UNITED STATES PATENT AND TRADEMARK OFFICE

APPLICATION NO.	FILING DATE	FIRST NAMED INVENTOR	ATTORNEY DOCKET NO.	CONFIRMATION NO.
10/688,750	10/17/2003	Paul J. Mollinger	CPS1540-241D	1991

Office Action Summary	Application No. 10/688,750	Applicant(s) MOLLINGER ET AL.	
	Examiner Lindsay M. Maguire	Art Unit 3692

DETAILED ACTION

FIG-12

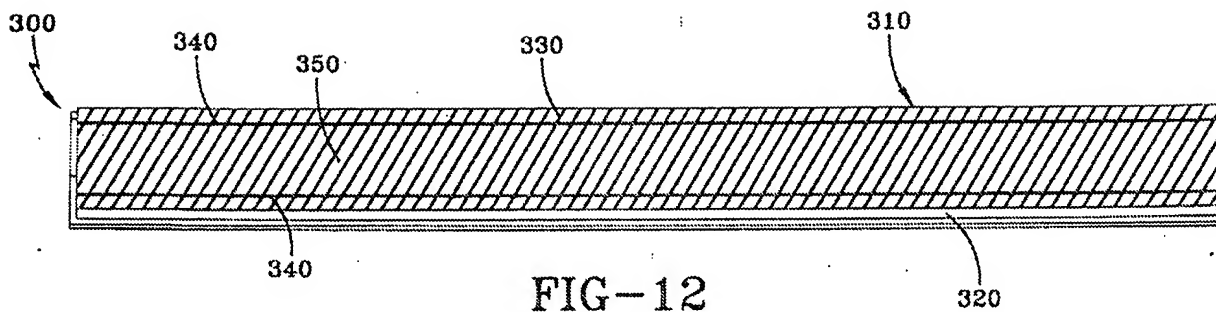
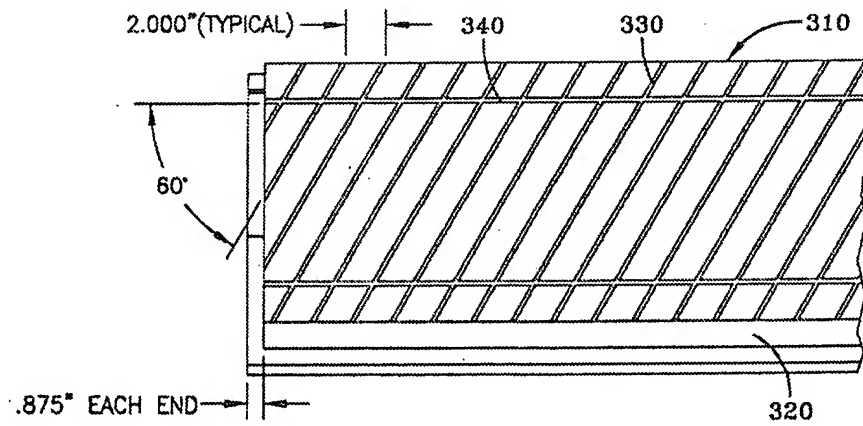
The drawings are objected to because writing in figures, other than the labeling of parts by numbers, is not permissible. Amended drawing sheets for Figures 12, 13, and 15 where all of the dimensions, titles, extraneous writing, etc. have been removed is required, or Applicant can cancel those three figures. Additionally it is improper for Figure 12 to contain more than one view. If applicant wishes for these three figures to be related or grouped together then it is advised that applicant name them "Figure 12A", "Figure 12B", and "Figure 12C".

The previously filed replacement drawing sheets filed on November 20, 2006 have not been entered since, the aforementioned drawing objections had not been corrected to meet the requirements as mentioned above. Applicant has not provided a corrected copy of Figures 12, 13, and 15 in this request for continued examination of the application. This requirement is therefore made **Final**.

Do Not
Enter
2/23/07
[Signature]

Corrected drawing sheets in compliance with 37 CFR 1.121(d) are required in reply to the Office action to avoid abandonment of the application. Any amended replacement drawing sheet should include all of the figures appearing on the immediate prior version of the sheet, even if only one figure is being amended. The figure or figure number of an amended drawing should not be labeled as "amended." If a drawing figure is to be canceled, the appropriate figure must be removed from the replacement sheet, and where necessary, the remaining figures must be renumbered and appropriate changes made to the brief description of the several views of the drawings for
